SERVICE BULLETIN

Service Bulletin No. 475C
(Supersedes Service Bulletin No. 475B)
Engineering Aspects are
FAA Approved

SUBJECT: Crankshaft Gear Modification and Assembly Procedures

MODELS AFFECTED: All Lycoming direct drive piston aircraft engines (including VO-360 and IVO-360; excepting O-320-H, O-360-E, LO-360-E, TO-360-E, LTO-360-E, and TIO-541 series engines).

Figure 1. Details for Repairing Pilot Diameter of Crankshaft

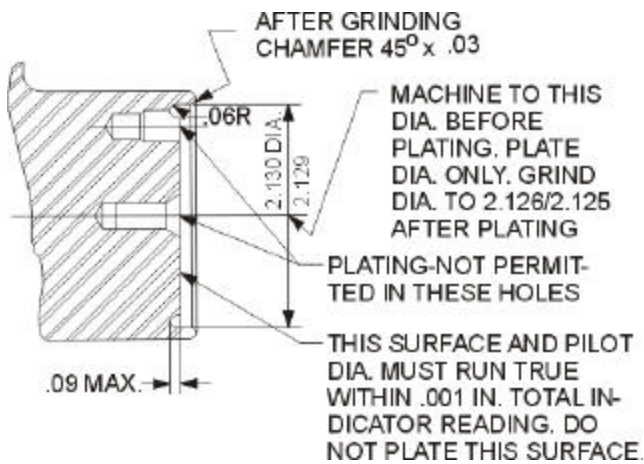
3. Check the pilot diameter of the counterbore on the end of the crankshaft for size and evidence of damage. This diameter should not exceed 2.1262 inches when measured at any location. If found to be oversize, the crankshaft may be repaired as described in the following steps. Do not attempt to reuse a crankshaft with an oversize pilot diameter.

- a. After removing the dowel, machine the pilot diameter in the end of the crankshaft to 2.129/2.130 inch as shown in the illustration. See Figure 1. Also, cut the .09 deep x .06R undercut as shown.

- c. After plating, stress relieve the shaft by baking at 390° to 410°F for 3 to 5 hours.
 - d. Grind the plated pilot diameter surface to 2.125/2.126 inch. Note that the diameter must run true with rear main journal within .001 inch total indicator reading.

- e. Chamfer edge of pilot diameter 45° x .03 as shown in Figure 1.
- 4. If the dowel has been removed, check the condition of the dowel hole in the crankshaft. If out of round or oversize, ream as required for installation of an oversize dowel. Available oversize dowels and the corresponding size for reamed holes are shown in Table 1.
- 5. Install a new dowel in the crankshaft as shown in Figures 2 and 3. Insure that the correct dowel is installed.

Figure 2. Section Thru End of Crankshaft Showing Driven Height of STD-1065 Dowel

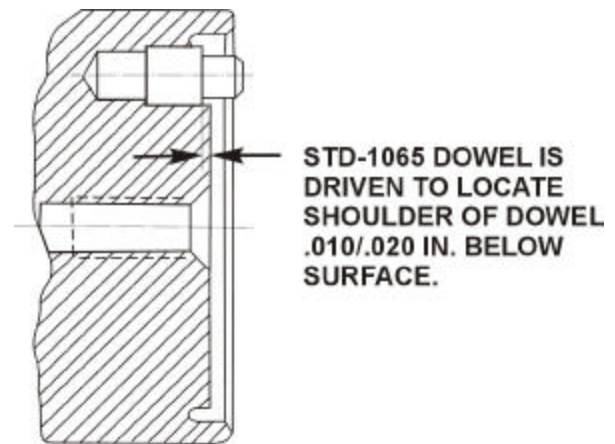
2. Check the condition of the dowel in the end of the crankshaft. It should be perfectly smooth with no indication of nicks or deformation. If it is out of round, it should be removed and replaced with a new one. Replacement instructions are in paragraph 4. If dowel condition is acceptable, insure that it is installed as shown in Figure 2 or 3.

Figure 4. Details of Crankshaft Dowel

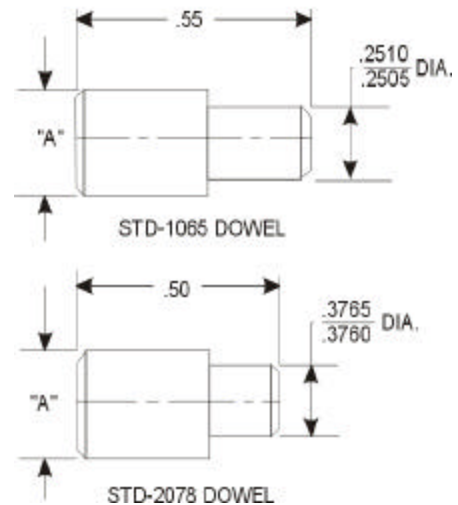
TABLE 1 – DOWELS AND DOWEL HOLES			
Dowel Part No.	Size Code on Dowel	Diameter of Dowel “A” (Figure 4)	Diameter of Dowel Hole in Crankshaft
STD-1065	None	.3095/.3100	.3085/.3095
STD-1065-P02	P02	.3115/.3120	.3105/.3115
STD-1065-P05	P05	.3145/.3150	.3135/.3145
STD-1065-P10	P10	.3195/.3200	.3185/.3195
STD-1065-P15	P15	.3245/.3250	.3235/.3245
STD-2078	None	.3760/.3765	.3750/.3760
STD-2078-P02	P02	.3780/.3785	.3770/.3780
STD-2078-P05	P05	.3810/.3815	.3800/.3810
STD-2078-P10	P10	.3860/.3865	.3850/.3860
STD-2078-P15	P15	.3910/.3915	.3900/.3910

Figure 5. Details for Rework of Crankshaft Gears to Current Configuration

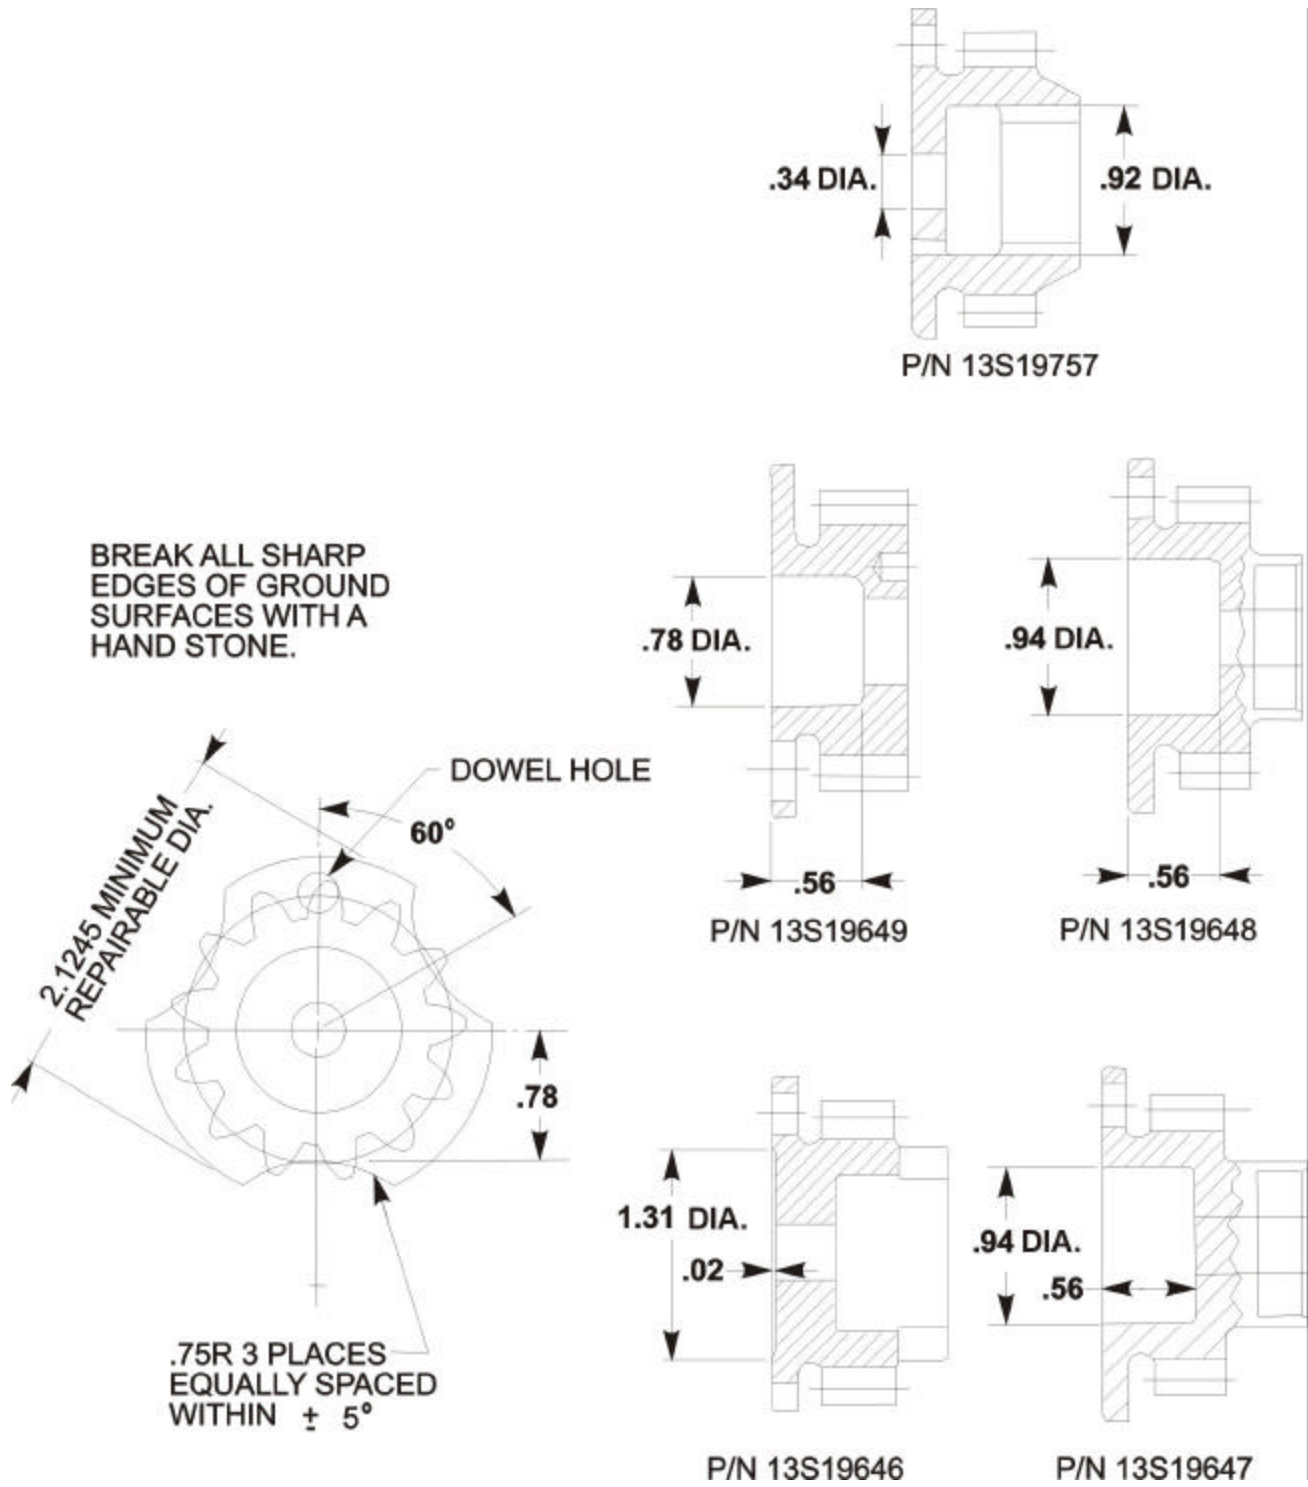
CRANKSHAFT GEARS FOR APPLICABLE ENGINES ARE NOW MANUFACTURED WITH THREE 3/4 INCH RADIUS SCALLOPS CUT INTO THE O.D. OF THE PILOT FLANGE AND A COUNTERBORE ON THE BACK SIDE OF THE GEAR. THESE ENLARGED SCALLOPS HAVE BEEN ADDED TO ALLOW INSPECTION OF THE GEAR AND CRANKSHAFT ASSEMBLY. SERVICEABLE GEARS MUST BE MODIFIED AS SHOWN IN FIGURE 5. PRIOR TO BEING REASSEMBLED ON THE CRANKSHAFT, OR A NEW GEAR THAT HAS BEEN MANUFACTURED TO THIS CONFIGURATION MUST BE INSTALLED. BEFORE MODIFYING THE GEAR, MEASURE THE DIAMETER OF THE PILOT FLANGE. IF IT IS LESS THAN 2.1245 INCH, IT SHOULD NOT BE RESUED. THE ORIGINAL 2.1250/2.1255 DIMENSION OF THE CRANKSHAFT GEAR MUST BE RESTORED WITH A FLASH COPPER PLATE OF UP TO .0005 INCH MAX.

NOTE: Revision "C" revises Table 2 and Figure 5.

Figure 6. Rear End View of Crankshaft Showing Associated Parts

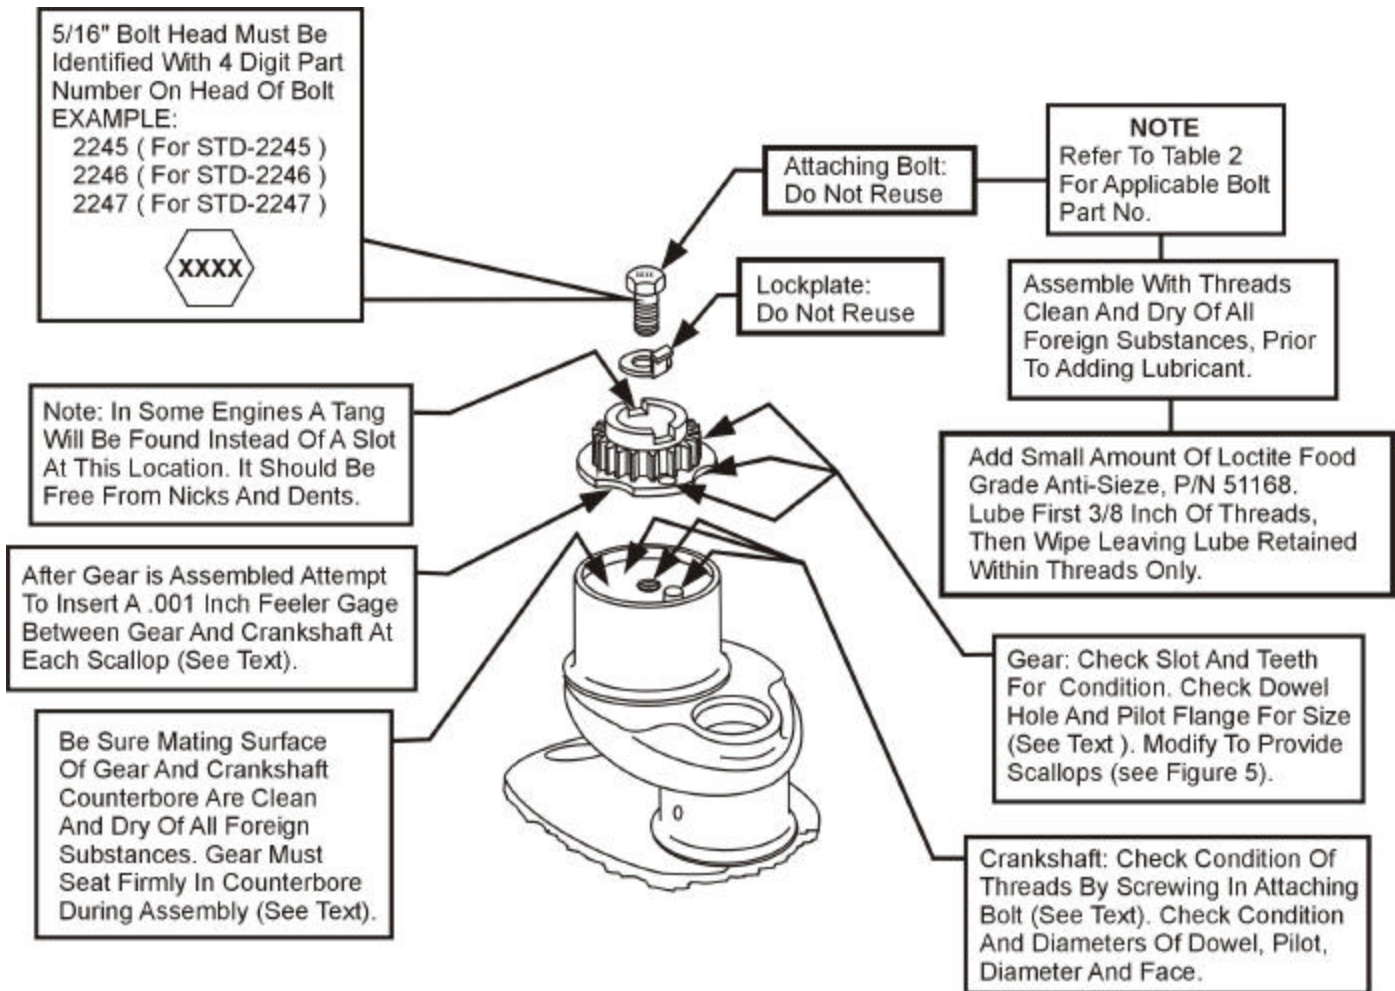
6. Assemble the gear to the crankshaft **using both a new lockplate and bolt**. Refer to Figure 6. The correct bolt, lockplate and dowel for each gear are shown in Table 2. Tighten the bolt to 125 in.-lbs. torque, then with a hammer and brass drift, tap lightly around the pilot flange of the gear and listen for sharp solid sounds from the hammer blows that would indicate that the gear is seated against the crankshaft. As a check on the seating against the crankshaft, attempt to insert a pointed .001 inch thick feeler gage or shim stock between the gear and crankshaft at each of the three scallops. The .001 feeler gage, or any smaller feeler gage, must **NOT** fit between the two surfaces at any location. (.001 feeler gage is used as an indicator, however, there must be no clearance between crankshaft and gear.) Retighten the gear attaching bolt to the proper torque. Tighten the 5/16 inch bolt to 204 in.-lbs. torque or the 1/2 inch bolt to 660 in.-lbs. torque. Measure the clearance between the O.D. of the gear flange and the pilot I.D. of the crankshaft. There should not be more than .0005 inch clearance at any point.

Figure 7. Minimum Dimension of Crankshaft

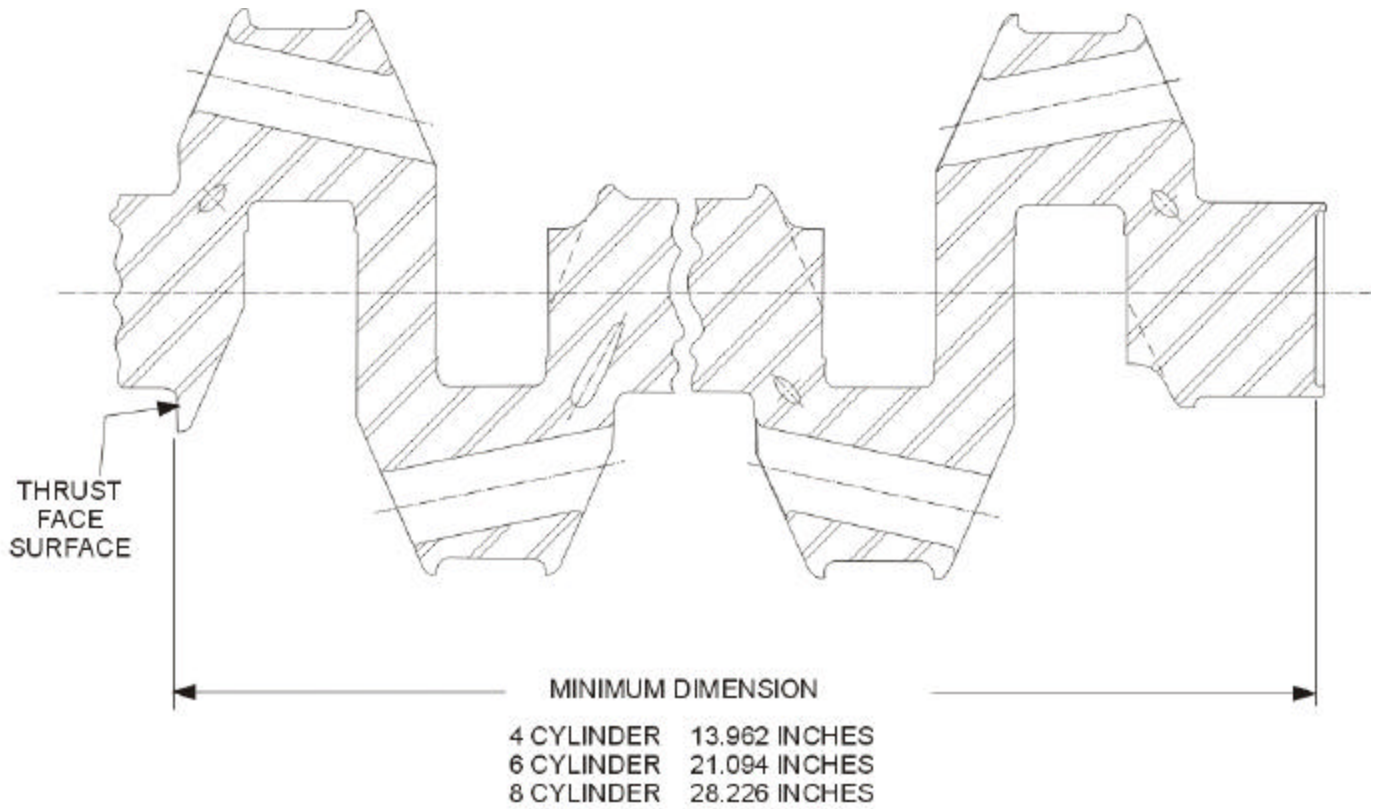
THE CRANKSHAFT COUNTERBORED GEAR MOUNTING FACE SHOULD BE CHECKED FOR DAMAGE. IF THE SURFACE REQUIRES REPAIR OTHER THAN SPECIFIED IN “CAUTION” ON PAGE 1, THE CRANKSHAFT SHOULD FIRST BE MEASURED AS SHOWN IN FIGURE 7. IF THE CRANKSHAFT MEASURES MORE THAN THE MINIMUM DIMENSION SHOWN IN FIGURE 7, THE SURFACE MAY BE REWORKED DOWN TO THE DIMENSIONS SHOWN. (DO NOT PLATE THIS SURFACE.) THE SURFACE MUST BE TRUE WITHIN .001 IN. TOTAL INDICATOR READING TO REAR MAIN BEARING AND THE SURFACE FINISH MUST BE HELD TO 45 TO 90 MICRONS.

INSURE MINIMUM DIMENSION IS MEASURED BETWEEN THRUST FACE SURFACE AND PILOT.
